Subject: Submittal of Approved TerraPower, LLC Topical Report: Regulatory Management of Natrium Nuclear Island and Energy Island Design Interfaces

**TerraPower, LLC Topical Report NATD-LIC-RPRT-0001-A, Revision 0, Regulatory Management
of Sodium Nuclear Island and Energy Island Design Interfaces**

SUBJECT: TERRAPOWER, LLC – FINAL SAFETY EVALUATION FOR TOPICAL REPORT NATD-LIC-RPRT-0001, “REGULATORY MANAGEMENT OF NATRIUM NUCLEAR ISLAND AND ENERGY ISLAND DESIGN INTERFACES,” REVISION 0 (CAC: 000431 / EPID: L-2022-TOP-0045)

TERRAPOWER, LLC – FINAL SAFETY EVALUATION OF TOPICAL REPORT NATD-LIC-RPRT-0001, “REGULATORY MANAGEMENT OF NATRIUM NUCLEAR ISLAND AND ENERGY ISLAND DESIGN INTERFACES,” REVISION 0 (EPID: L-2022-TOP-0045)

Figure 2: Natrium Nuclear Island

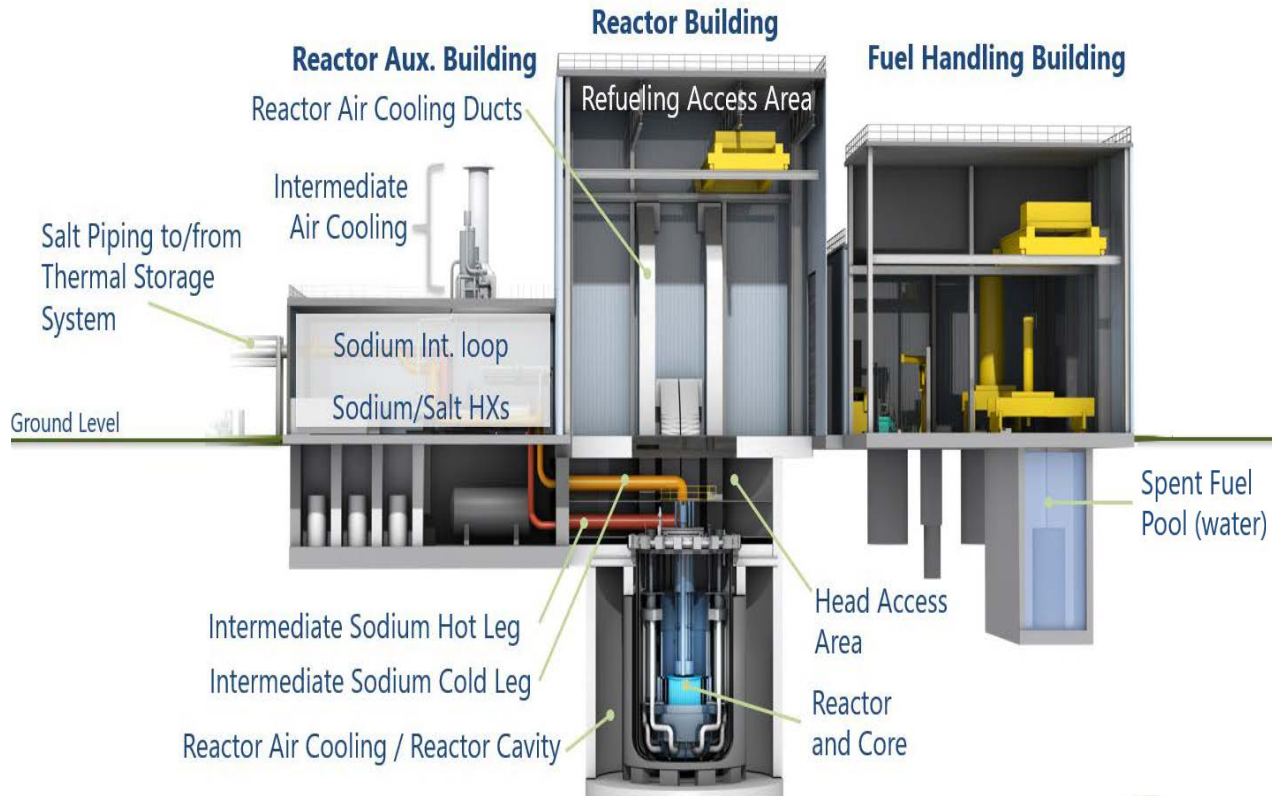
Section 5.1 of the TR also discusses the IHT system. The IHT is located on the NI. In the IHT system, liquid sodium is circulated by mechanical intermediate sodium pumps (ISPs) from the IHX tube side to the tube side of the sodium-salt heat exchangers (SHXs). There are two IHT loops, each of which is connected to one IHX and two SHXs. Between the IHX and the SHX, the sodium passes through sodium-air heat exchangers (AHXs), which are a part of the IAC system. The IHT also contains expansion and drain tanks to handle the sodium. The IHT system can be seen in TR Figure 2.

The NRC staff determined that the design of the IHT system, as described in the TR, is a key aspect of the plant for NI-EI independence because (a) it provides a pathway for heat to be removed from the fuel by the IAC (discussed below in Section 1.6) and (b) it provides additional thermal inertia that reduces the effects on the reactor core resulting from transients on the EI.

Figure 3: Reactor Air Cooling and Intermediate Air Cooling

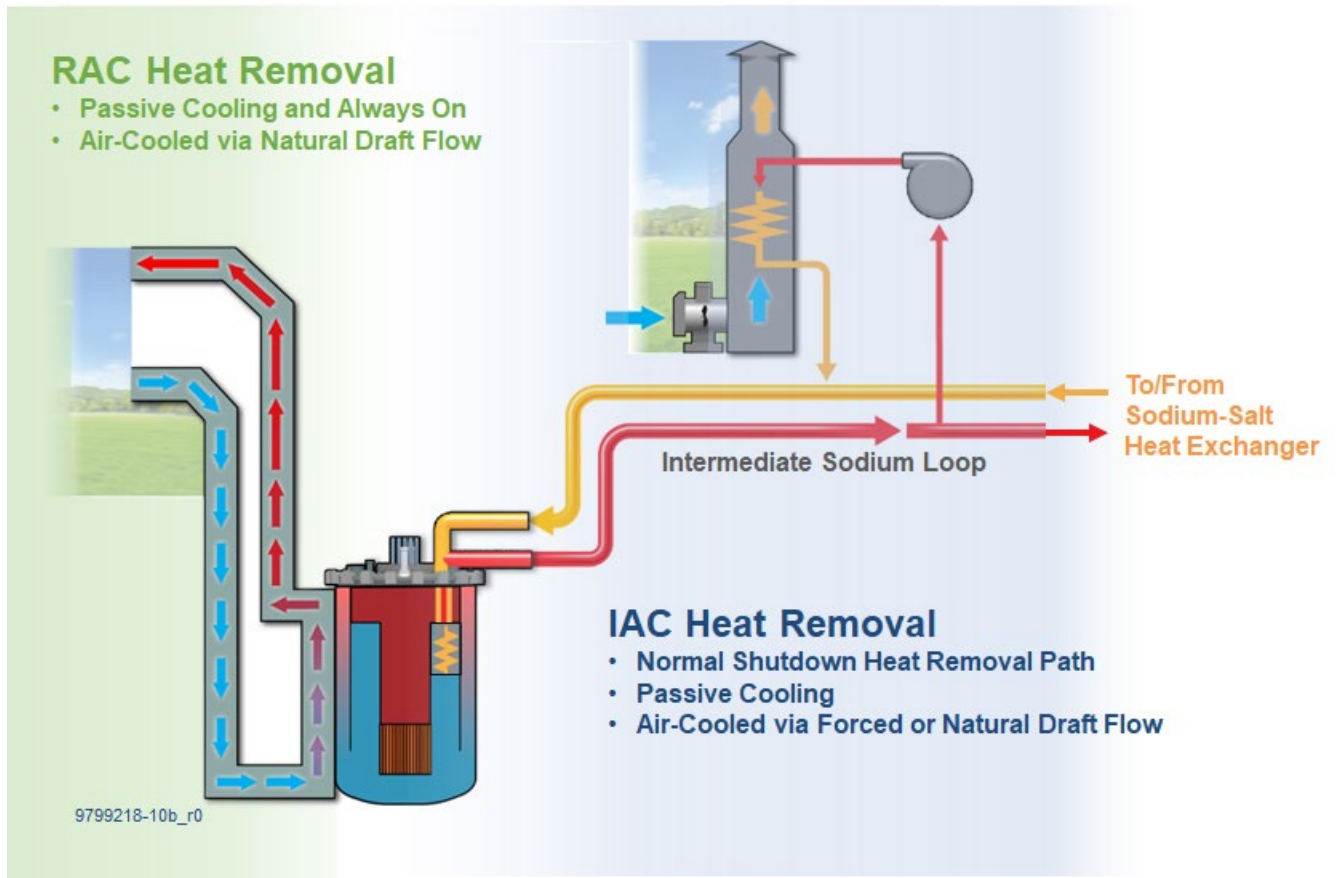
The reactor air cooling (RAC) and intermediate air cooling (IAC) systems are discussed in Section 5.1 of the TR and illustrated in TR Figure 3. These systems provide residual heat removal capability for the Sodium reactor.

The IAC, as mentioned previously in Section 1.3 of this SE, consists of an AHX on the IHT system along with blowers and dampers on the air side of the AHX. In active mode, the IAC provides controlled, forced flow of air across the AHX that allows heat to be transferred from the IHT to the atmosphere. In passive mode, the dampers are designed to fail open so that natural draft flow of outside air can remove heat from the IHT without active systems, as a supplement to the RAC.

As discussed in Section 4.2 of the TR, the IAC (in forced flow mode) is intended to serve as the normal shutdown cooling system, while the RAC is designed to be able to remove all decay heat from the reactor using purely passive means. The NRC staff notes that because radiation heat transfer is a key contributor to RAC performance, the reactor may need to heat up for the RAC to remove heat effectively. The NRC staff audited preliminary analyses performed by TerraPower that included these systems and verified that they appear to be capable of performing the necessary heat removal function, based on the current design. The NRC staff stresses, however, that the analyses audited were preliminary and are subject to confirmation as design details are developed and finalized.

The NRC staff determined that the RAC and IAC, as described in the TR, are a key aspect for NI-EI independence because they provide the capability to remove all decay heat using systems located solely on the NI.

Figure 5: Energy Island Diagram

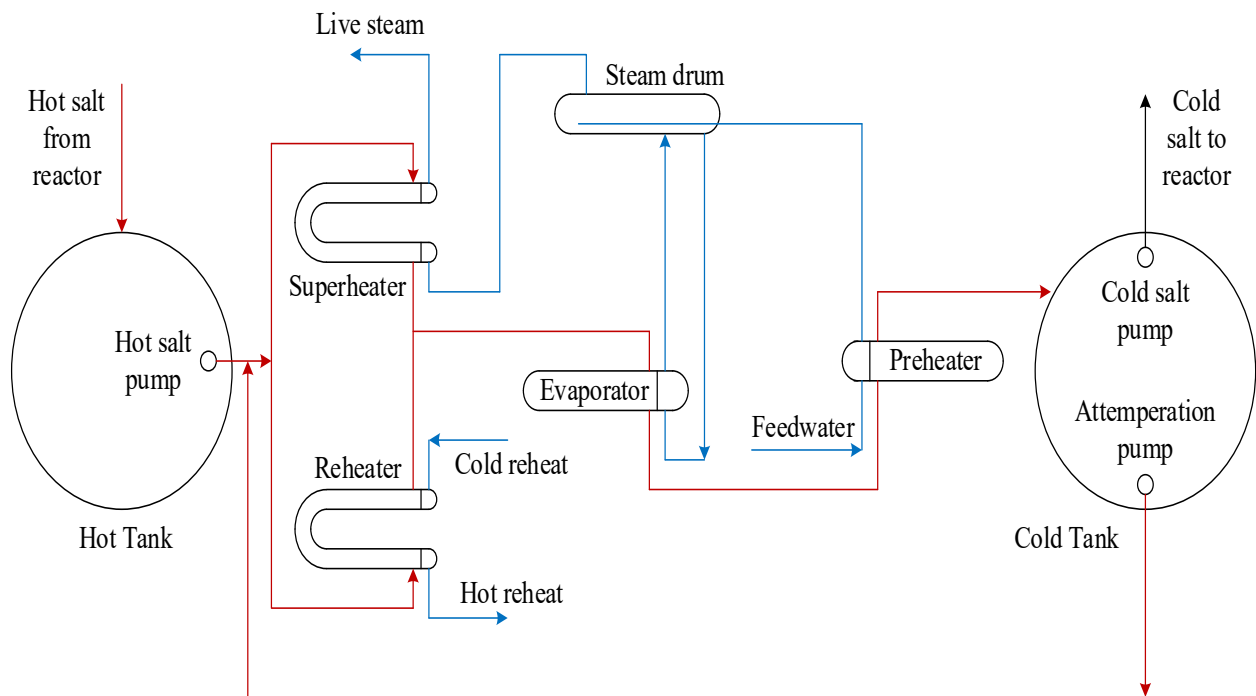
EI systems are discussed in Section 5.2 of the TR. These include the TSS, the steam generation system, the condensate and feedwater system, the turbine and generator and associated systems, and the heat rejection system. A diagram of some of these systems is provided in Figure 5 of the TR.

Figure 6: SSC Classification Process (Figure 4-1, SSC Function Safety Classification Process from NEI 18-04)

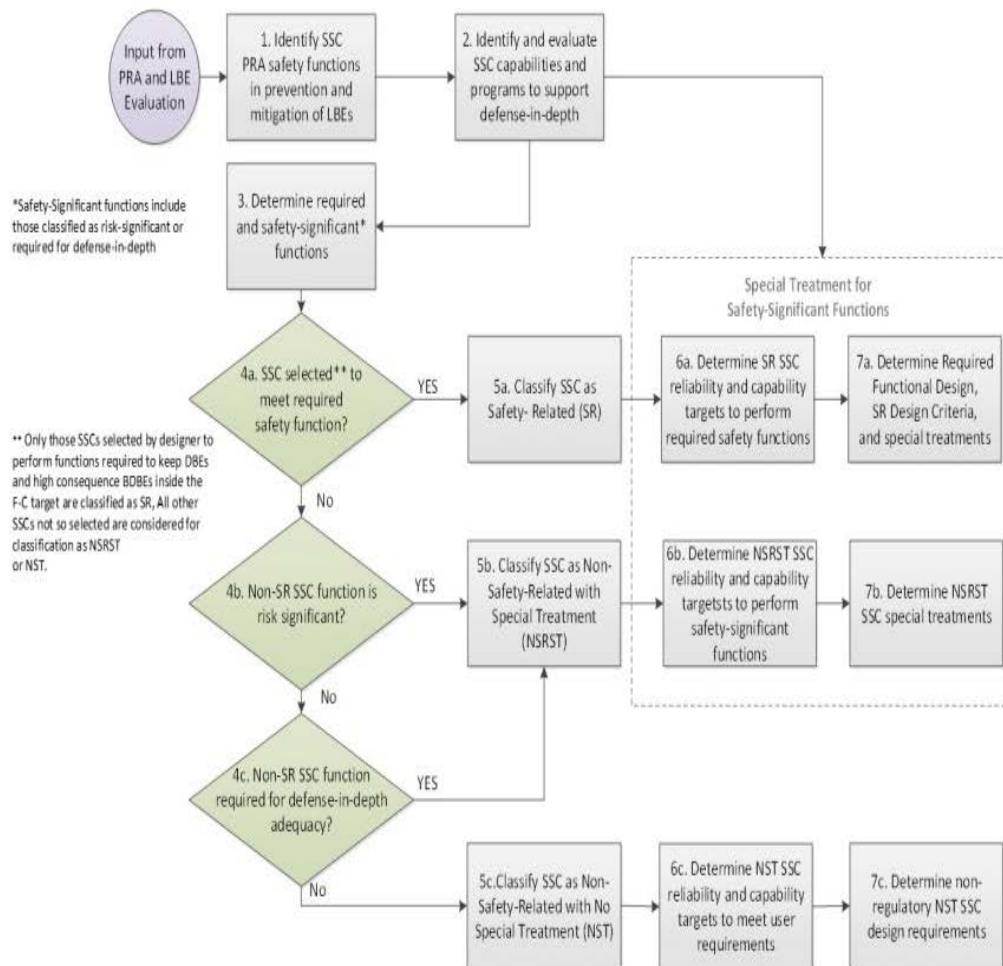
Figure 6 of the TR provides a flow chart with the NEI 18-04 SSC classification process. Additionally, a high-level overview of the ultimate safety-classification categories is provided in Section 4 of NEI 18-04. The categories are:

In addition to these definitions provided in NEI 18-04, the NRC staff clarified in RG 1.233 that the NRC expects that “SSCs that provide essential support (including required human actions) for SR or NSRST SSCs will be classified in a manner consistent with the higher-level function, even if the supporting SSC is not explicitly modeled in the PRA.”

TerraPower determined that all SSCs on the EI would be NST according to the NEI 18-04 process because they are not needed to meet the required safety functions, do not provide risk-significant functions, and are not needed for DID. As described in Section 1.0 of this SE, the NRC staff reviewed TR summaries of proposed Sodium design features and basic plant transient responses as well as associated supporting analysis during a regulatory audit. With respect to DID considerations, TerraPower indicated in TR Sections 4.1 through 4.3 that there are multiple NI SSCs capable of accomplishing the plant safety functions and providing adequate DID without involving the EI. Based on the NRC staff’s review of this information, the NRC staff determined that a future applicant could be able to justify characterizing EI systems as NST for a Sodium design with these specified high-level features. The need for future applicants and licensees referencing the TR to demonstrate that EI SSCs are appropriately classified as NST is listed as one of the limitations and conditions in the Limitations and Conditions section of this SE.
